March 30, 2012

Michael Anderson, NYSDOT
Tappan Zee Bridge/I-287 Corridor Project Director
660 White Plains Road, Suite 340
Tarrytown, NY 10591

**RE: Comments on the Tappan Zee Bridge Hudson River Crossing Project Draft
Environmental Impact Statement**

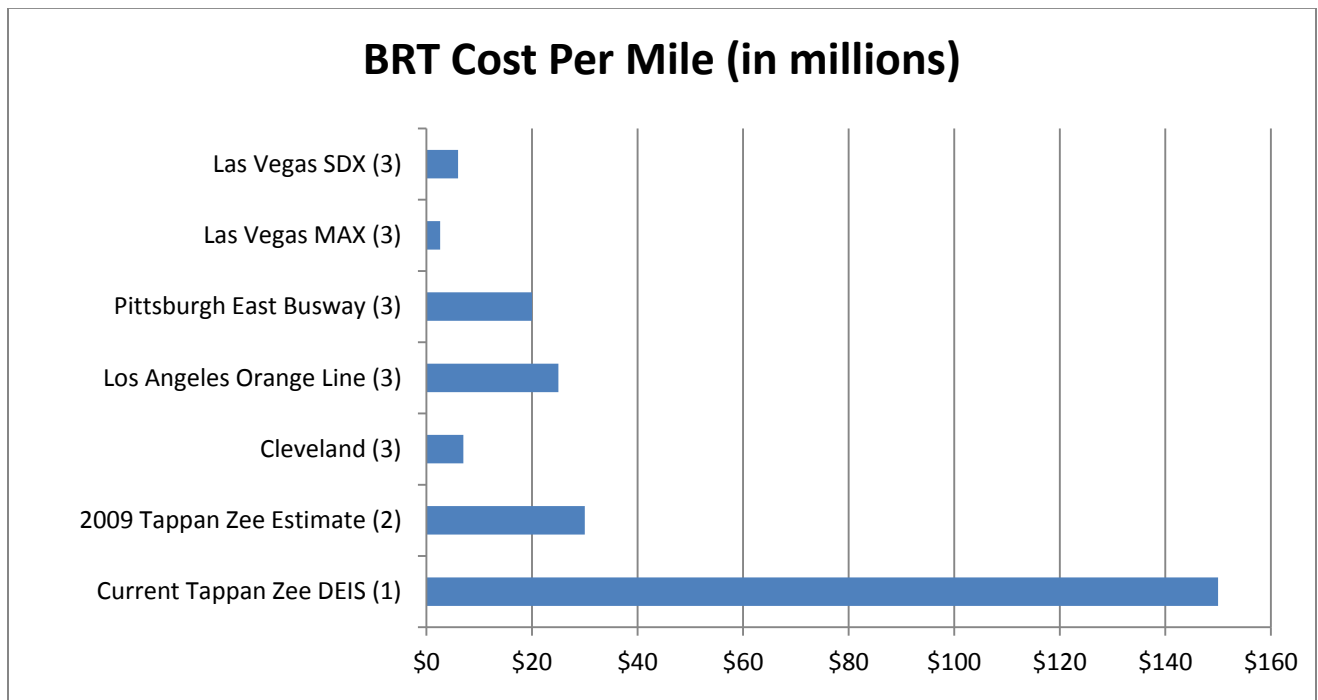
1. The cost of bus rapid transit offered by the state in the DEIS is completely out of line with past state studies as well as other BRT projects and the industry average

According to DEIS Appendix A-1 White Paper on Transit and the Tappan Zee Hudson River Crossing Project, the cost of BRT in the corridor will be between \$4.5 and \$5.3 billion. However, that cost is 4-5 times more than the \$897 million price predicted by the state’s 2009 Transit Mode Selection Report.

This means the cost of BRT is suddenly \$150 million per mile in the I-287 corridor. This amount is five times as much as the 2009 estimate of \$30 million per mile and completely out of line with the industry average of \$20 million per mile. The following chart is a cost per mile comparison with other projects and the state’s 2009 cost projection.
